RE: PA2001055: 235-273 Victoria Street, West Melbourne - Buildings and works and expansion of use planning permit application associated with an existing Education centre (Simonds Catholic College)

The purpose of this letter is to summarise Part 2 of our response to DELWPs Request for Further Information (RFI) letter dated 14 January 2021 (items 4-9). Part 1 of our response was provided to items 1-3 on 10 March 2021. As well as requesting further information, DELWP raised concerns about aspects of the proposal. This letter provides a response to these concerns also.

Figure 1: Shadow Diagrams at Winter Solstice, 9am.

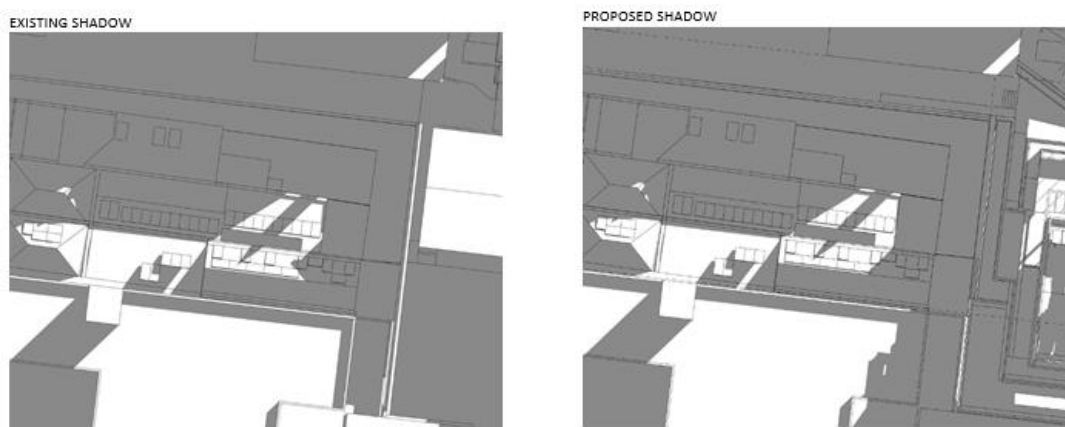
5. An assessment by a suitably qualified professional addressing the impacts of the overshadowing of solar panels on adjoining allotments.

In order to consider the reasonableness of overshadowing to the neighbouring solar panels at 62 and 64 Chetwynd Street, we have also prepared a shadow diagram for the winter solstice at 9am. This shows the impacts of shadowing as a worst-case scenario for the proposal (ie. when the greatest overall level of overshadowing currently occurs to the neighbouring properties) (refer to **Figure 1** below).

Figure 1 shows the existing and proposed development in respect to the 62 and 64 Chetwynd Street dwellings. The diagrams show that less shadowing will occur to the solar panels due to the proposed scheme (shadowing of 64 Chetwynd remained the same, there was a decrease to 62 Chetwynd). Based on the positive results of this worst-case scenario, a further assessment was not regarded necessary by a suitably qualified professional, as the "reasonable" test could be readily contemplated.

We note that on the 22 September equinox one single panel at 62 Chetwynd was identified as experiencing a heightened level of shadowing due to the proposal (current 16%, proposed 95%). Given that the panel is currently overshadowed and no new panel will be overshadowed, we again formed the view that an appreciation of "reasonableness" could be determined without further assessment.
